Kentucky Power Company
 KPSC Case No. 2019-00154
 Commission Staff's First Set of Data Requests
 Dated September 16, 2019

- KPSC 1_2** Refer to the Ali Testimony, unnumbered page 14, lines 12-17.
- a. Identify the nine project components that were previously designated as Supplemental Projects but are now reclassified as Baseline Projects by PJM.
 - b. Explain when these project components were designated by PJM as Baseline Projects along with the identified need for these particular project components and the determination that these components represent the optimal solution to address those needs.

Kentucky Power Company
KPSC Case No. 2019-00154
Commission Staff's 2nd set of Data Request
Dated October 10, 2019

B2761.1 – Scope Clarification /Cost Update Previously Presented: 10/6/2016 SRRTEP

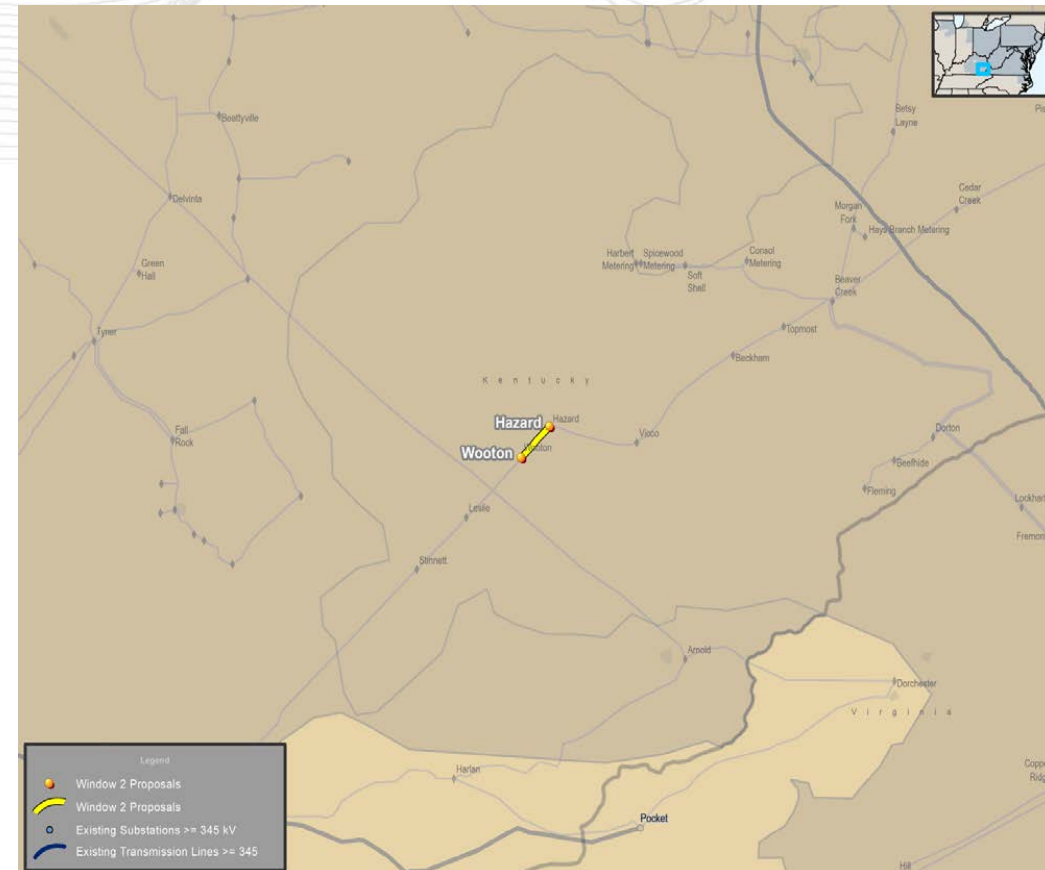
Original Scope Description: Replace the Hazard
161/138 kV Transformer
Original Estimated Cost: \$2.3 M

New Scope Description: Replace **and relocate**
the Hazard 161/138 kV Transformer **and circuit**
breaker 'M'. Upgrade protection scheme on the
new Transformer including installation of low side
breaker.

New Estimated Cost: \$ 3.8 M

AEP Transmission Zone: Baseline Hazard – Wooton 161kV Circuit

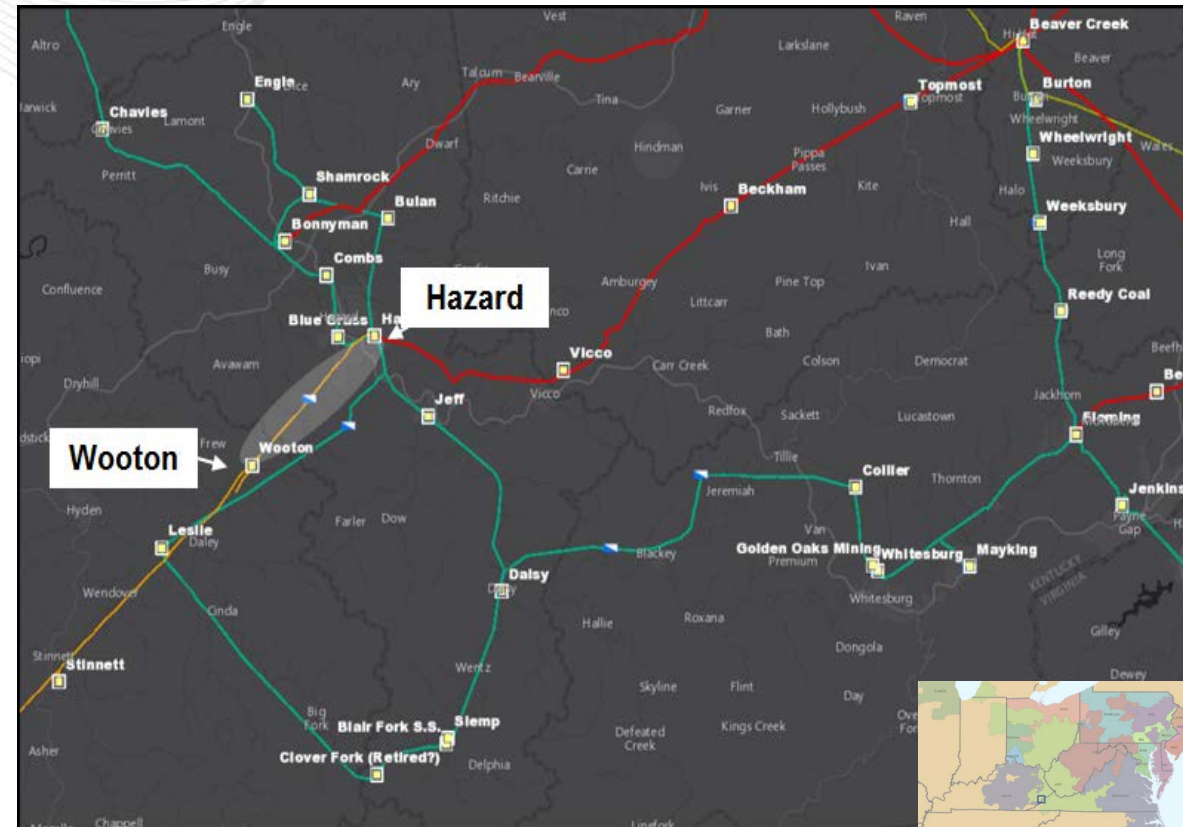
Original Scope Description: Rebuild the Hazard – Wooton 161 kV line utilizing 795 26/7 ACSR conductor (300 MVA rating).

New Scope Description: Rebuild the Hazard – Wooton 161 kV line utilizing 795 26/7 ACSR conductor (300 MVA rating). **Replace line relaying and associated termination equipment .**

New Estimated Cost: \$16.8 M

AEP Transmission Zone: Supplemental Hazard Station

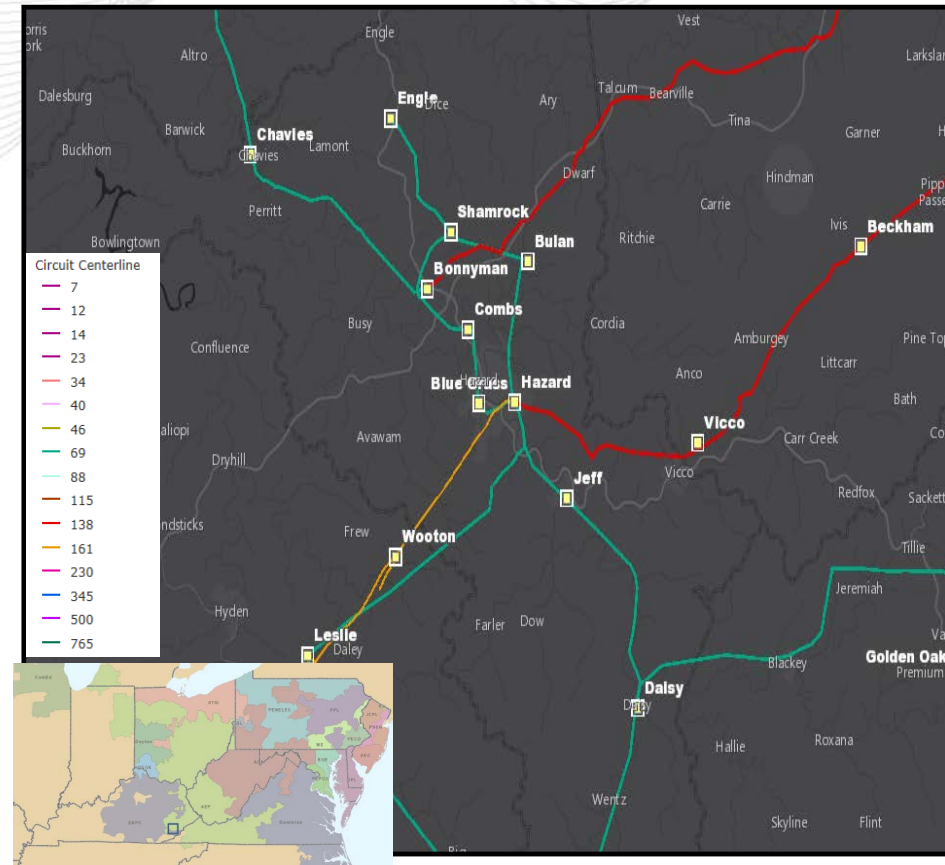
Circuit breakers S (1100 A, 11.3 kA) and E (1800 A, 27 kA) at Hazard station are FK type breakers all over 40 years old. Circuit breaker F at Hazard is a 1200 A, 31.5 kA CG type breaker. These are oil breakers that have come more difficult to maintain due to the required oil handling. In general, oil spills occur often during routine maintenance and failures with these types of breakers. Other drivers include PCB content, damage to bushings and number of fault operations exceeding the recommendations of the manufacturer. Breakers S, E, and F have experienced 82, 184, and 193 fault operations respectively, well above the manufacturer's recommendation of 10.

Circuit breaker M (2000 A, 40 kA) will need to be relocated in association with the baseline project to replace the existing 161/138 kV transformer at Hazard station (b2761) in order to limit outage times. The breaker is an SF6-gas breaker, 29 years old and has experienced 21 fault operations, which exceeds the manufacturer's recommendation of 10.

Transformer #1 (1974 vintage, 50 MVA) and #2 (1973 vintage, 130 MVA) show dielectric breakdown (insulation), accessory damage (bushings/windings) and short circuit breakdown (due to amount of through faults). Transformer #1 also shows signs of corrosion on radiators as well as oil leaks.

Circuit Switcher BB a MARK V unit which have presented AEP with a large amount of failures and mis-operations. AEP has determined that all MARK V's will be replaced and upgraded with the latest AEP cap-switcher design standard. **Capacitor bank BB will need to be relocated in association with the baseline project to replace the existing 161/138 kV transformer at Hazard station (b2761).** Additional engineering design has indicated that Capacitor bank BB would not need to be relocated to accommodate the baseline 161/138 kV transformer replacement/relocation.

AEP Transmission Zone: Supplemental Hazard Station

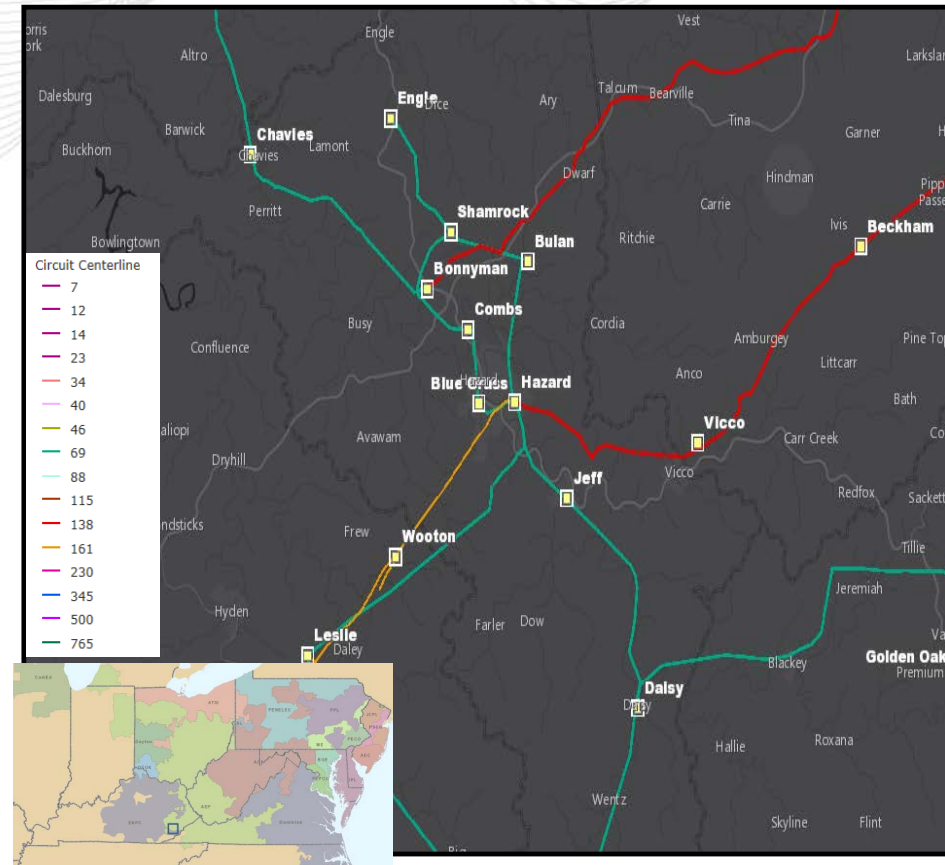
Capacitor switcher CC has oil leaks on all three phases and cannot be repaired. Capacitor bank CC was a non standard design and its components (fuses and cans) have begun to fail.

Safety concerns associated with existing equipment platforms at the station will also be addressed. The majority of the platforms at the station were field designed with thought of access, not safety, adequate clearances, or structural integrity in mind. Drainage issues at the station will also be addressed. Water from an adjacent parking lot and an incorrectly sloped 69 kV yard is causing water to pool on the fence line at Hazard Station.

A 138 kV circuit breaker will be added at Hazard station on the line exit towards Beckham station, along with a circuit switcher and low side breaker on transformer #1 to separate three dissimilar zones of protection. The 138 kV bus, the Hazard – Beckham 138 kV line, and the 138/69 kV transformer #1 are all on the same protection zone. This can lead to mis-operations and over tripping.

138 kV circuit switchers will be added to transformer #2 and #4, as well as low side breakers on transformer #2, #3, and #4 to separate four dissimilar zones of protection.

Transmission Operations has requested a 69 kV bus tie circuit breaker be installed to improve operational flexibility to the 69 kV networks served out of Hazard. The 69 kV tie breaker will also help facilitate the retirement of Capacitor AA which is currently located off the line to Bonnyman, is beginning to show issues, and requires its VBM type cap switcher replaced. Tying the 69 kV buses together requires the 138/69 kV transformers to be the same size to avoid circulating currents and to be able to serve the 69 kV area independently for loss of one.

AEP Transmission Zone: Supplemental Hazard Station

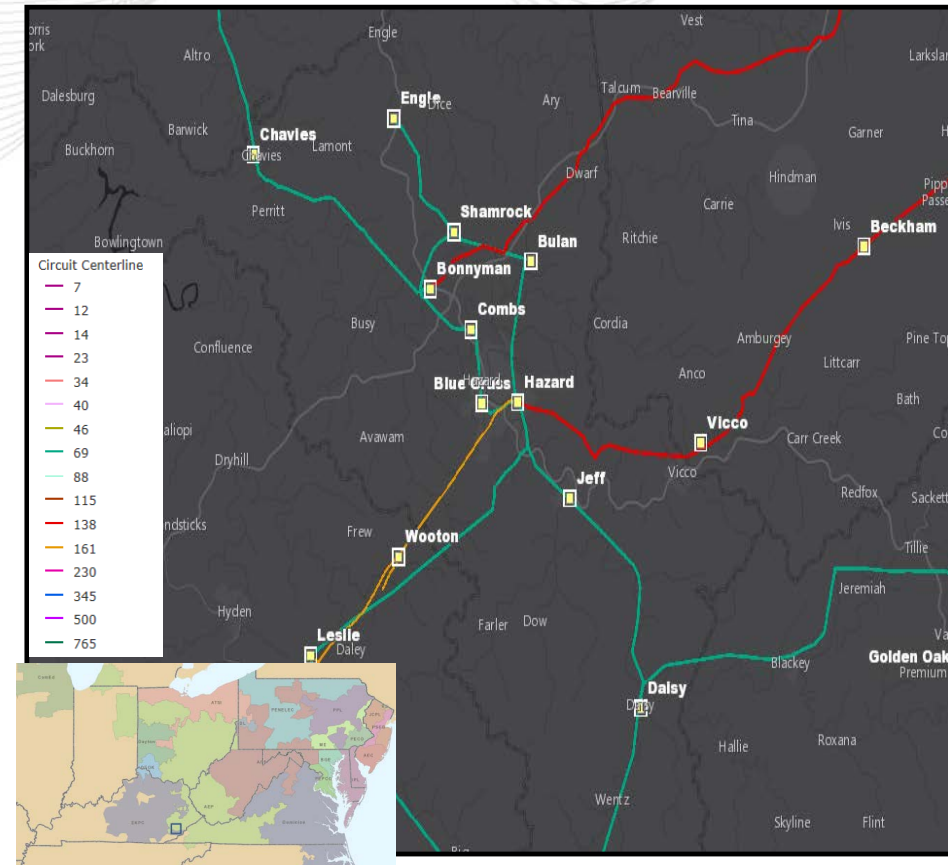
Selected Solution:

Install a new 3000 A 40 kA 138 kV circuit breaker at Hazard station on the line exit towards Beckham station. (s1412.1)

Add a 138 kV circuit switcher to the high side of transformer #4. (s1412.2)

Replace 138 kV capacitor bank and switcher BB with a new switcher and 43.2 MVAR capacitor bank. (s1412.3)

Replace 138/69 kV transformers #1 and #2 with new 138/69 kV 130 MVA transformers with 138 kV circuit switchers on the high side and 3000 A 40 kA 69 kV breakers on the low side. (s1412.4)

Replaces 69 kV circuit breakers S, E, and F with 3000 A 40 kA 69 kV circuit breakers with a bus tie 3000A 69 kV circuit breaker being installed between the existing 69 kV box bays. (s1412.5)

Replace 69 kV capacitor bank and switcher CC with a new switcher and 28.8 MVAR capacitor bank. 69 kV capacitor bank and switcher AA will be retired.

Replace 161 kV circuit breaker M towards Wooton with a 161 kV 3000 A 40 kA breaker. (s1412.6)
This work is already included in the baseline project (b2761).

Add a 3000 A 40 kA 138 kV circuit breaker to the low side of 161/138 kV transformer #3. (s1412.7)
This work is already included in the baseline project (b2761).

Address safety and access issues associated with existing equipment platforms and drainage issues at the station. (s1412.8)

Estimated Transmission Cost: ~~\$20.0M~~ \$23.3 M
